ERRATA

PTI DC45.1-12

Recommendations for Stay Cable Design, Testing, and Installation

The following errata item was added on January 8, 2014:

Fig. C3.1 – Fatigue safety philosophy. (Note: Δ_1 is quality assurance [17 MPa coupled bar, 69 MPa strand and uncoupled bar, 103 MPa wire] and Δ_2 is length effect, anchorage riser, safety [35 MPa].)

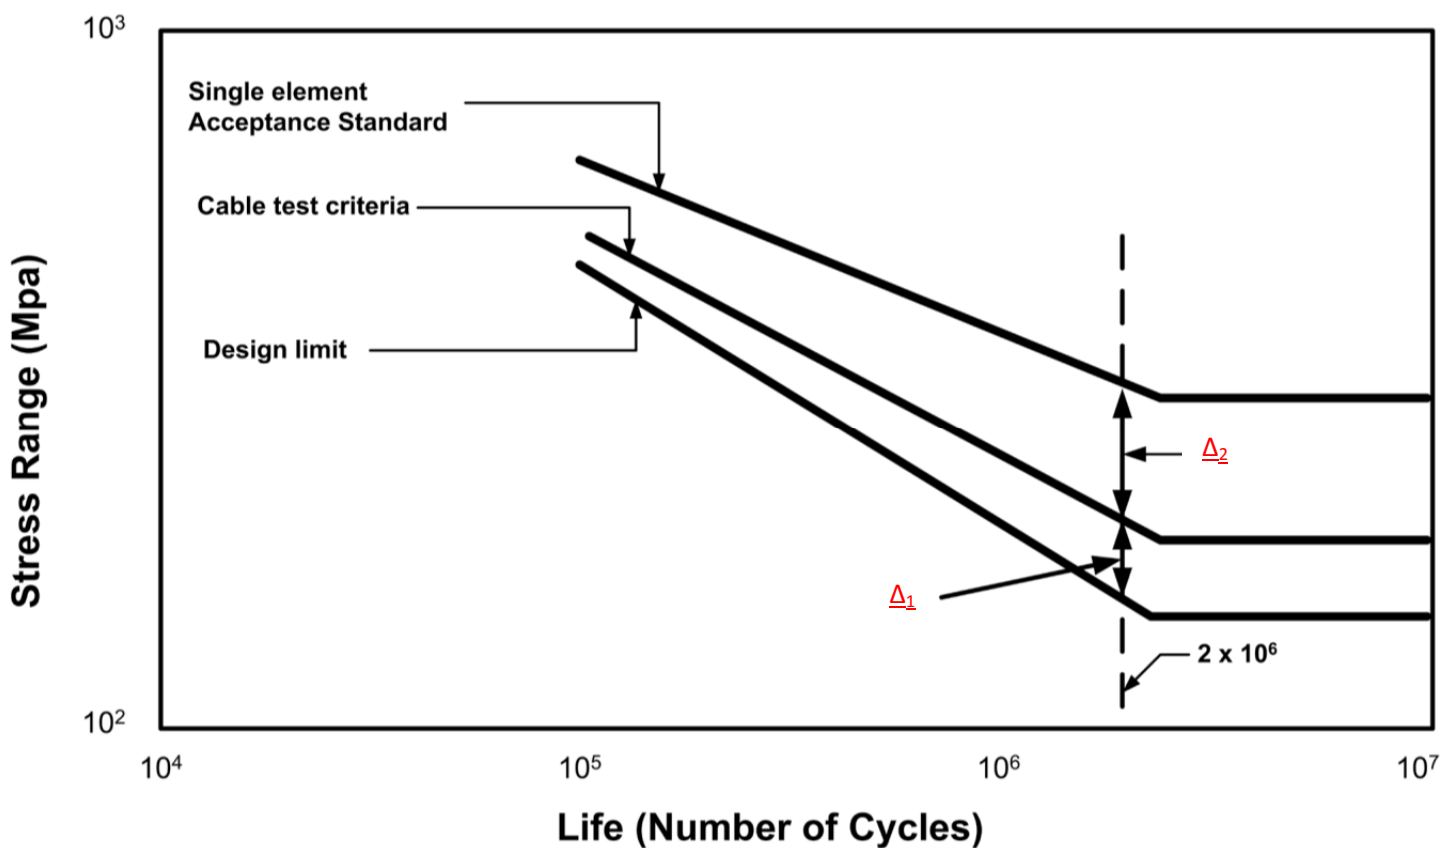
Page 12, Fig. C3.1:
